ATTACHMENT A

PROPOSED CHANGES TO APPENDIX A,

OPERATING LICENSES DPR-19 and DPR-25

DRESDEN STATION

Figure 6.1-1

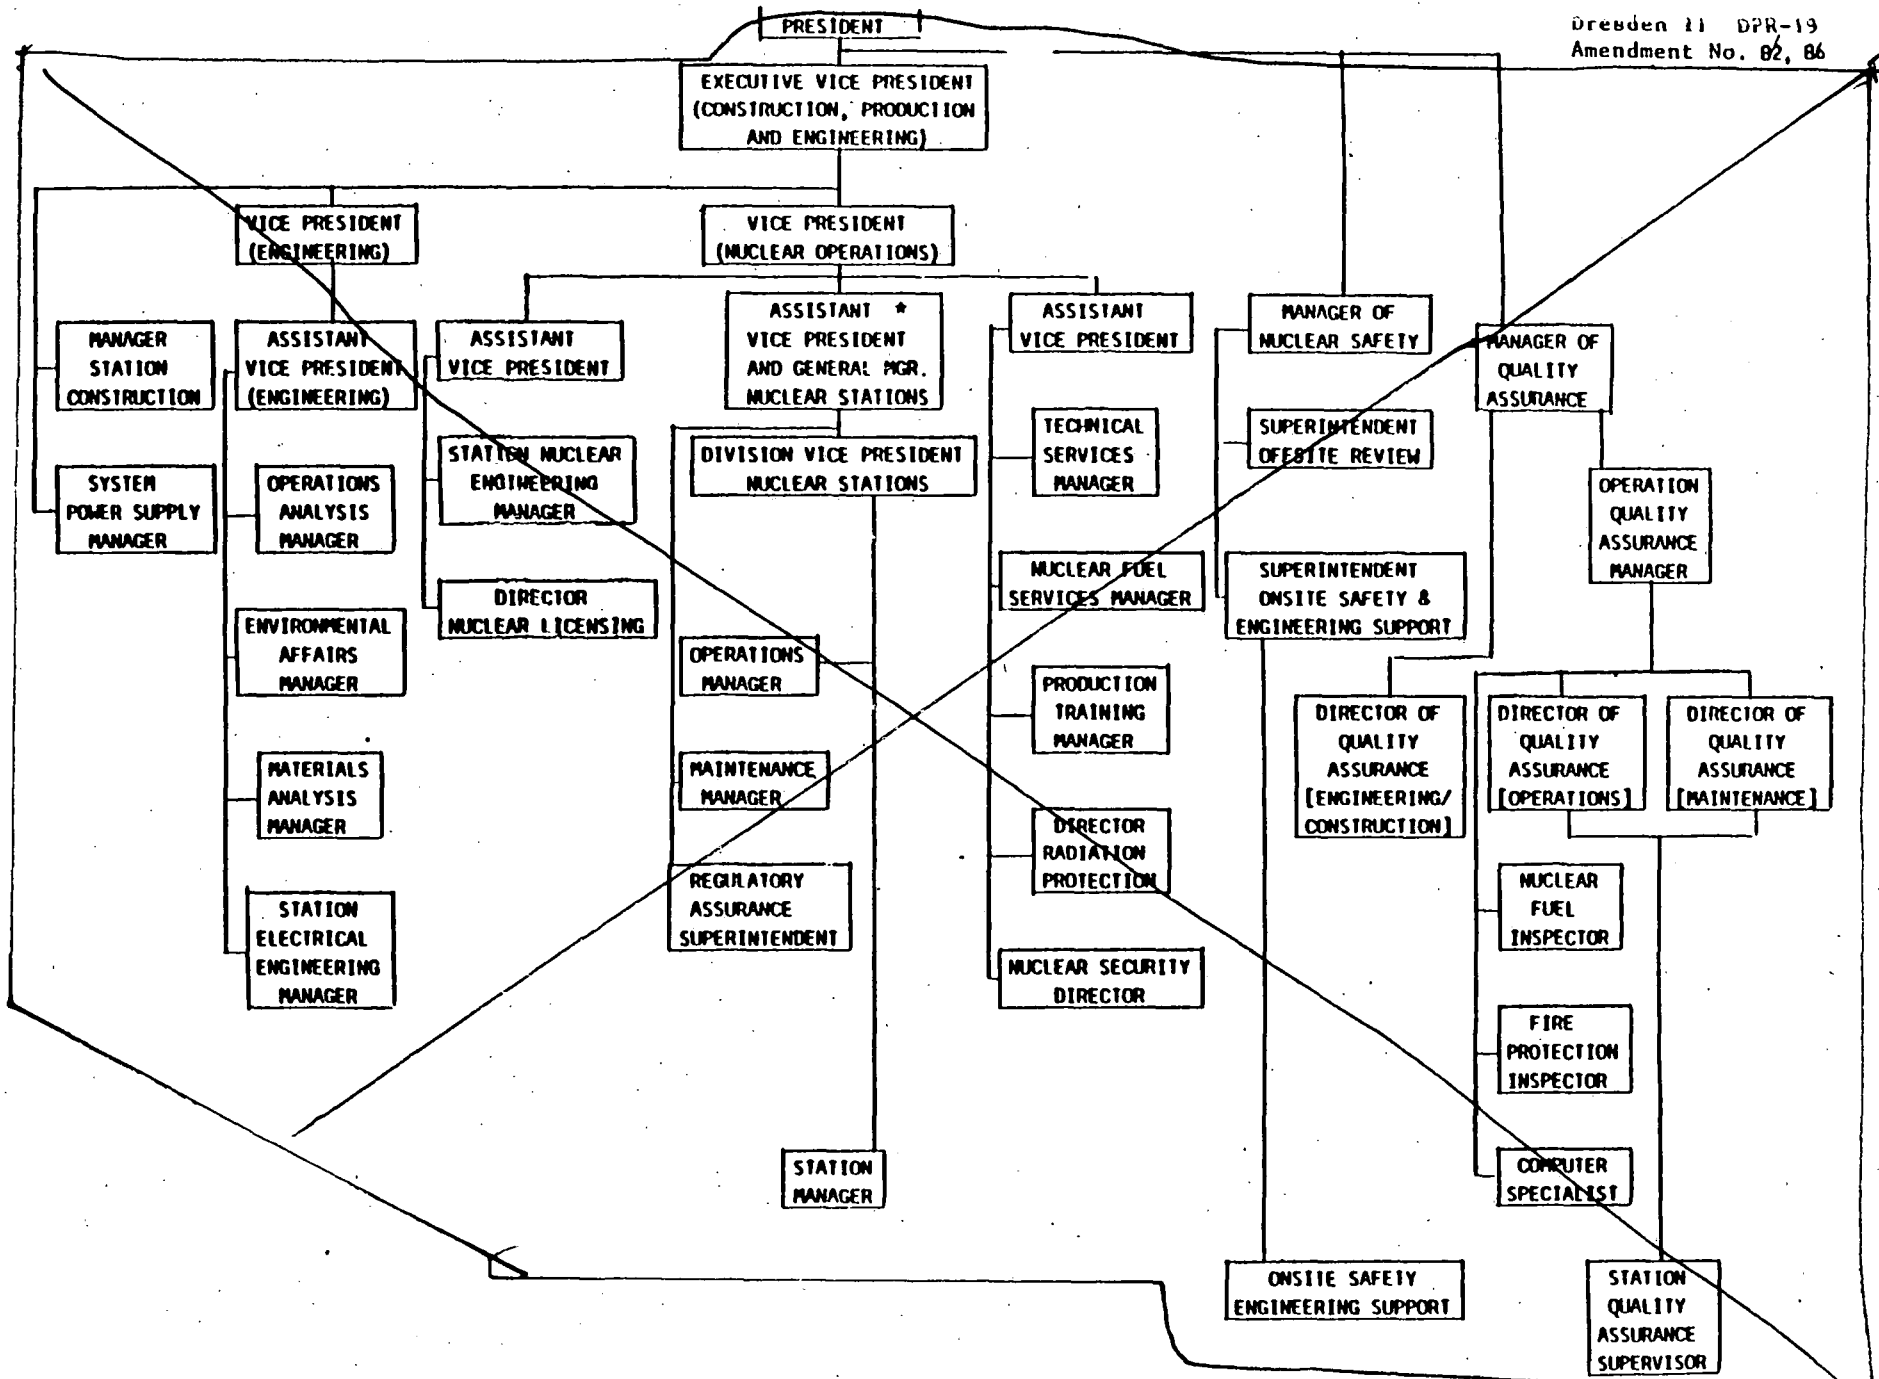
~~B. **DELETED** The organization chart of the corporate management which relates to the operation of this station is shown in Figure 6.1-1 and the normal functional organization chart for operation of the station is shown in Figure 6.1-2.~~

~~OPPSITE ORGANIZATION~~
~~DELETED~~
6-3

The proposed Technical Specification amendment requests several changes. The first change involves the removal of organizational Figures 6.1-1 and 6.1-2 and the revision of TS 6.1.A, 6.1.B, and 6.1.C in accordance with the guidance provided in Generic Letter 88-06. The second proposed revision corrects several position titles that changed due to corporate reorganization. The third change clarifies the distribution requirements for onsite review documentation discussed in TS 6.2.

Figure 6.1-1
~~OFFSITE ORGANIZATION~~
~~DELETED~~

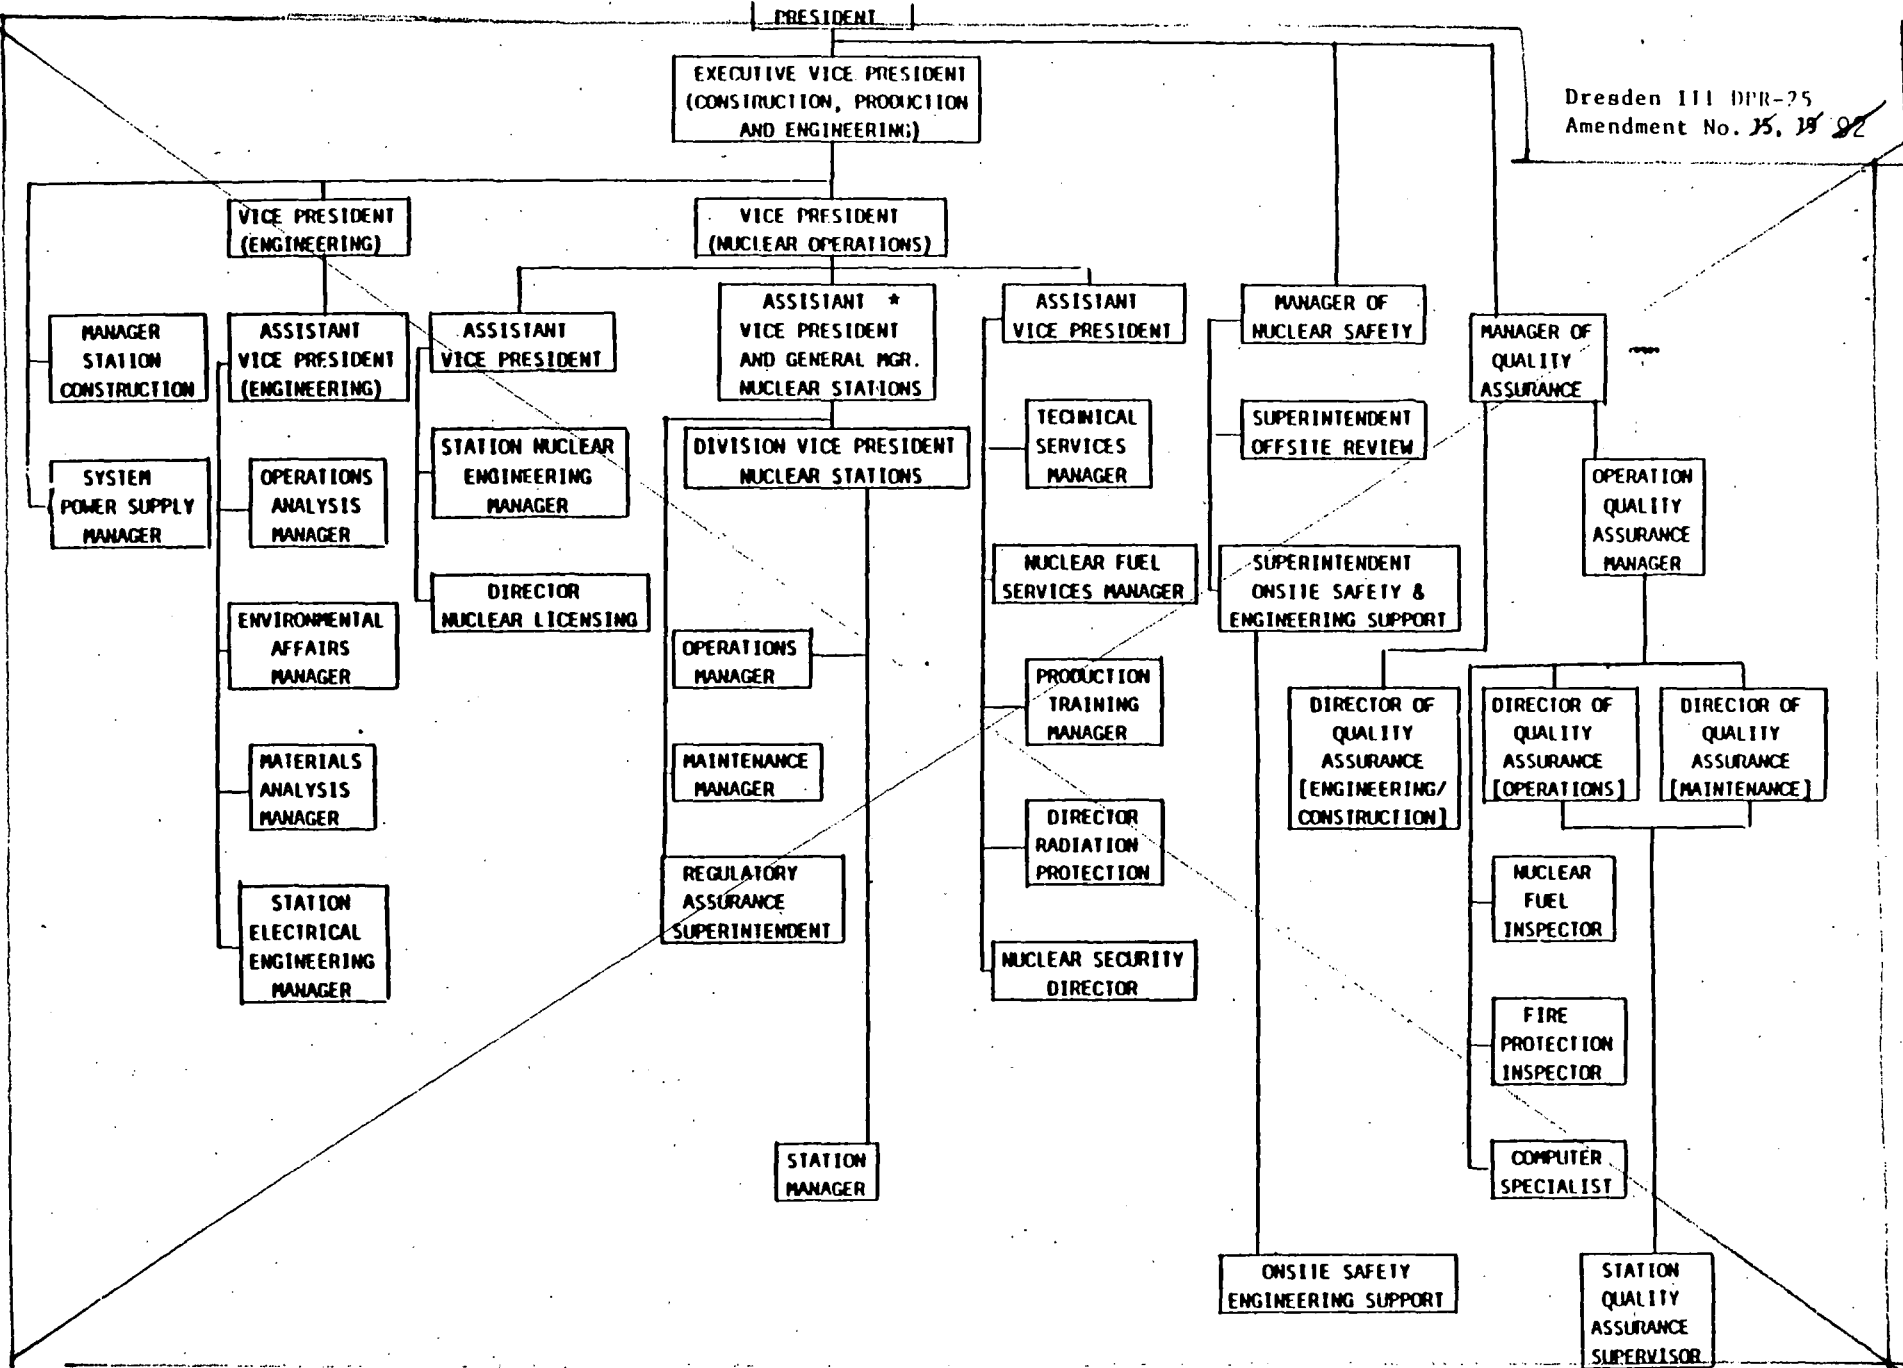
~~DELETED~~
B. ~~The organization chart of the corporate management which relates to the operation of this station is shown in Figure 6.1-1, and the normal functional organization chart for operation of the station is shown in Figure 6.1-2.~~
